Re: Fireflower
2120 Eubank Blvd. NE
Traffic Circulation Layout
Engineer's Stamp 03-14-23 (H21-D056)

Based upon the information provided in your submittal received 03-17-23, the above referenced plan cannot be approved for Building Permit until the following comments are addressed:

**TRAFFIC
CIRCULATION
LAYOUT PLAN**

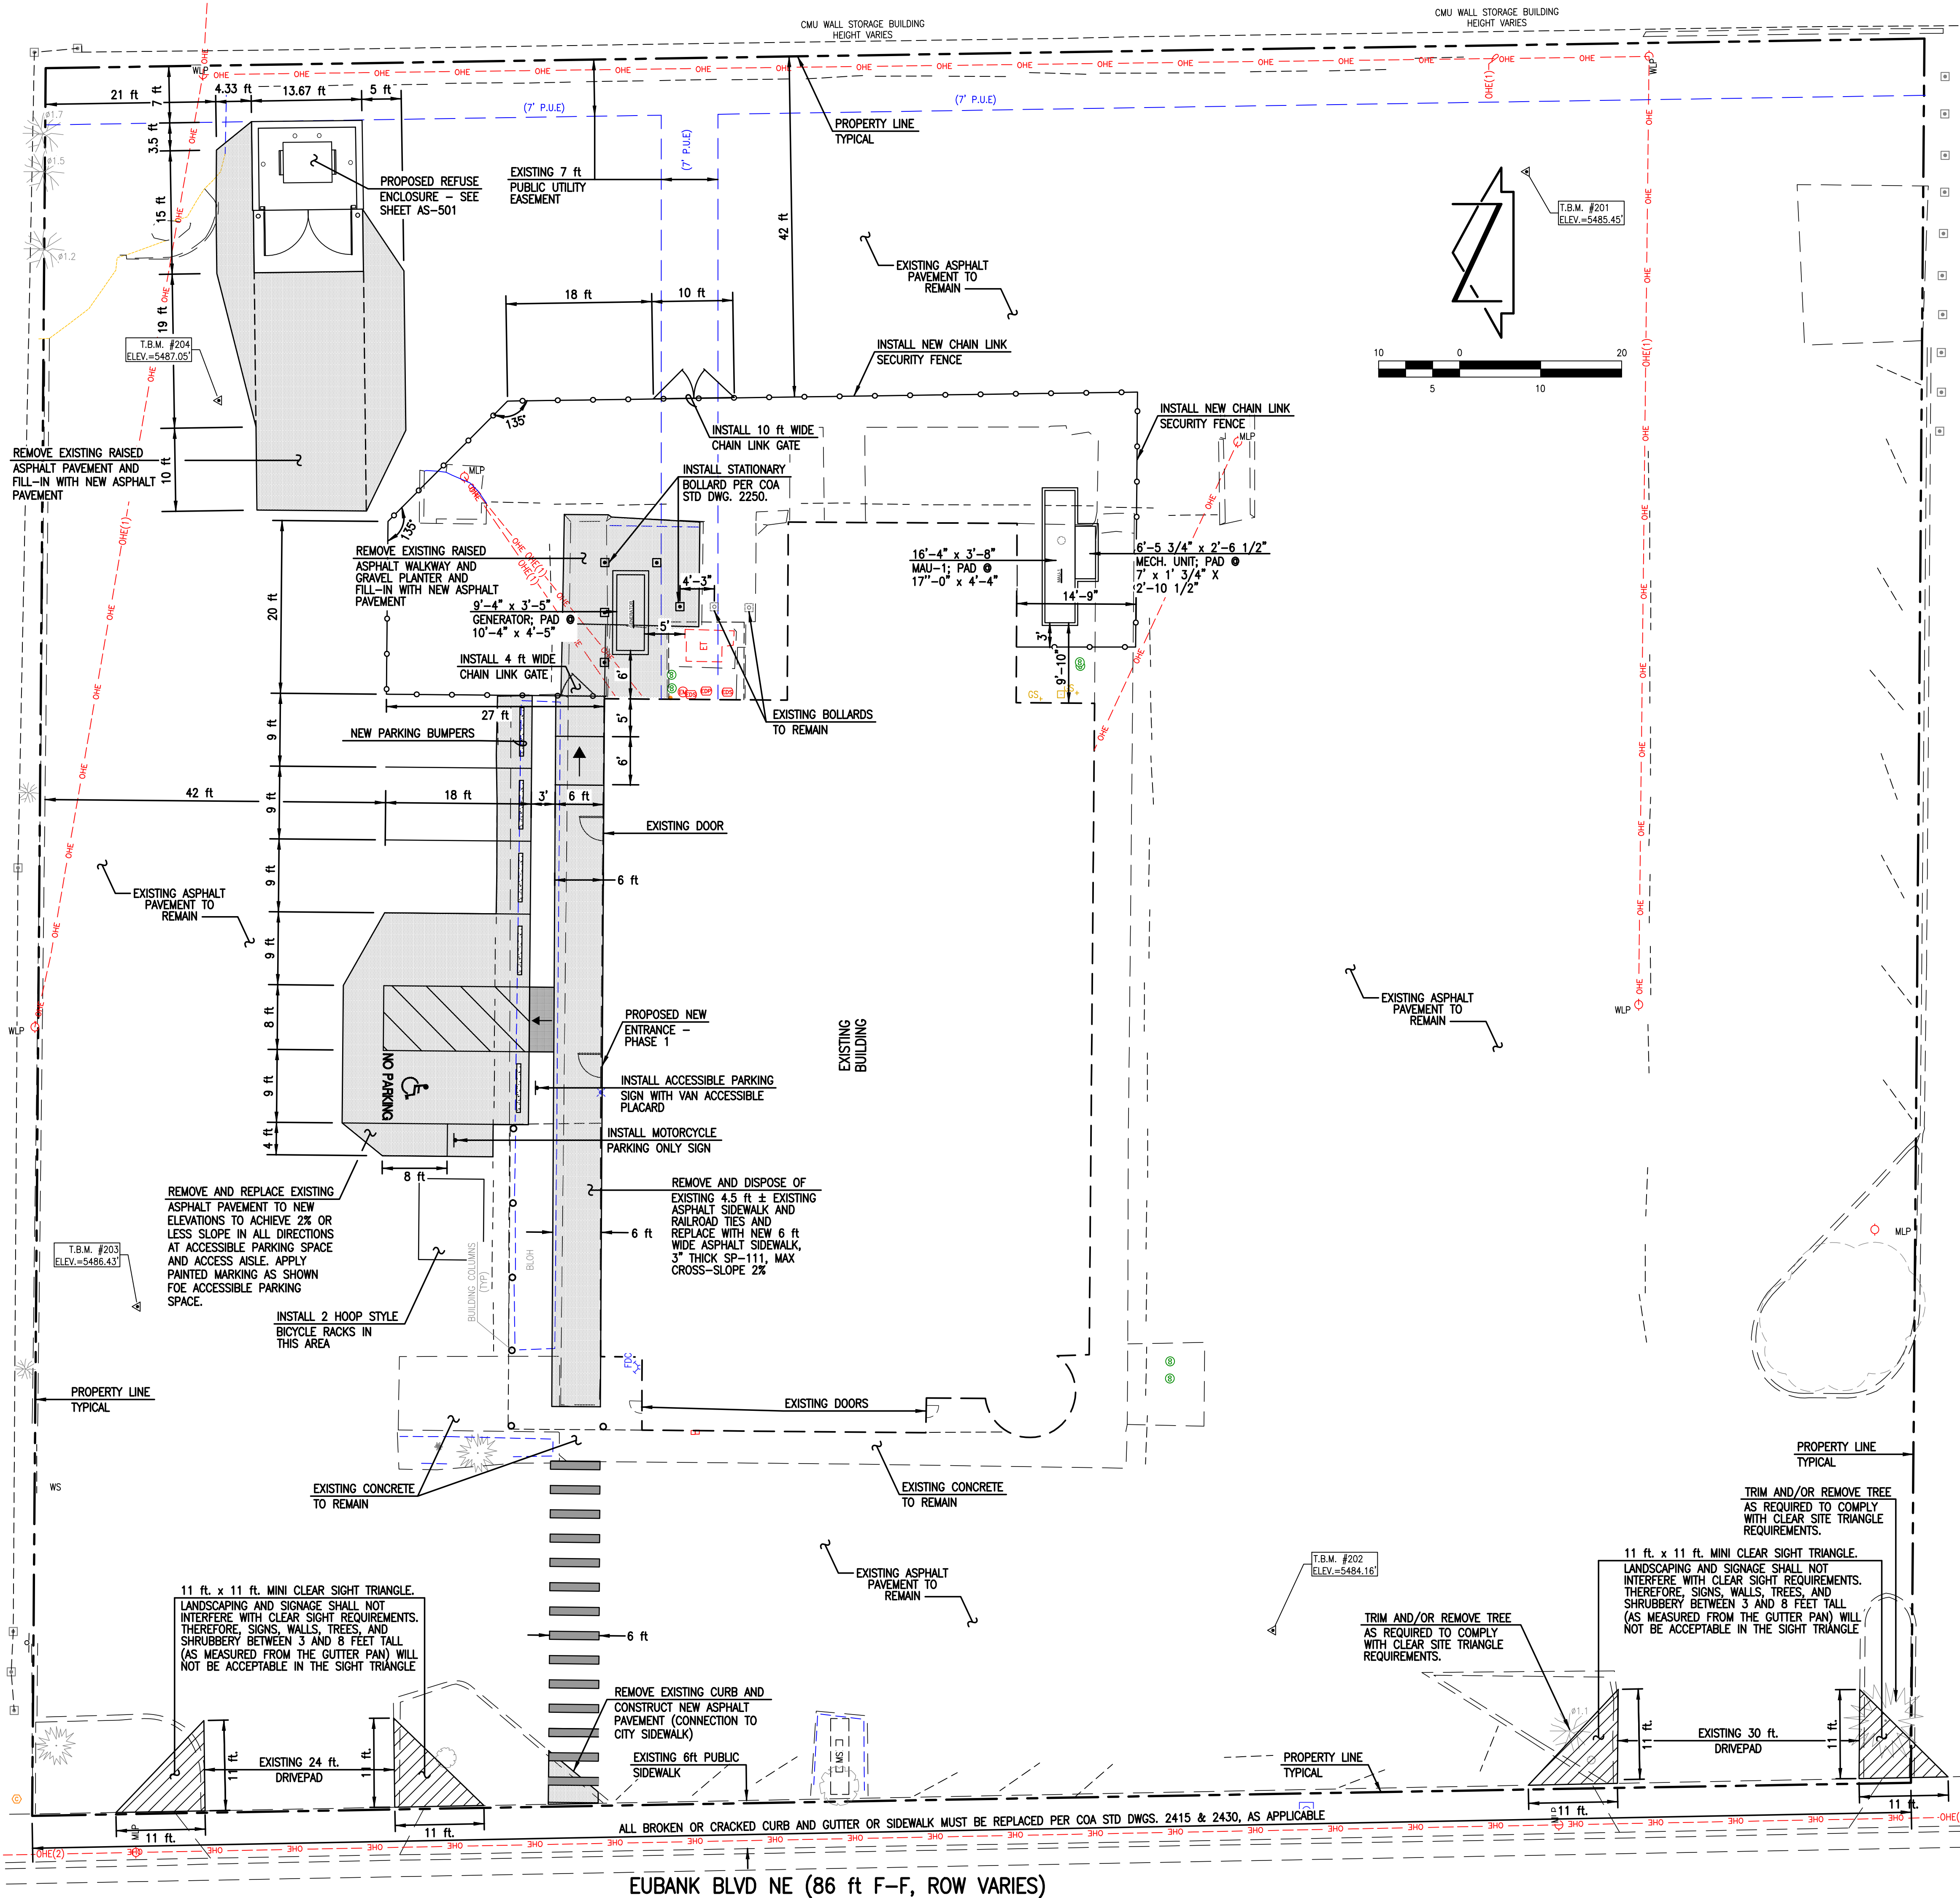
1. Please provide ADA compliant driveway accesses. Suggestion: provide a sidewalk taper per COA std dwg 2425B.
2. Define ADA pathways by form the public sidewalk and from the ADA aisle to the building entrance, by labeling of ramps or flush pavement.
3. Please provide ADA ramp details, if any.
4. The ADA access aisles shall have the words **"NO PARKING"** in capital letters, each of which shall be at least one foot high and at least two inches wide, placed at the rear of the parking space so as to be close to where an adjacent vehicle's rear tire would be placed. (66-1-4.1. B NMSA 1978)
5. The pavement marking "MC" should be shown in the opposite direction for motorcycles entering the parking space.
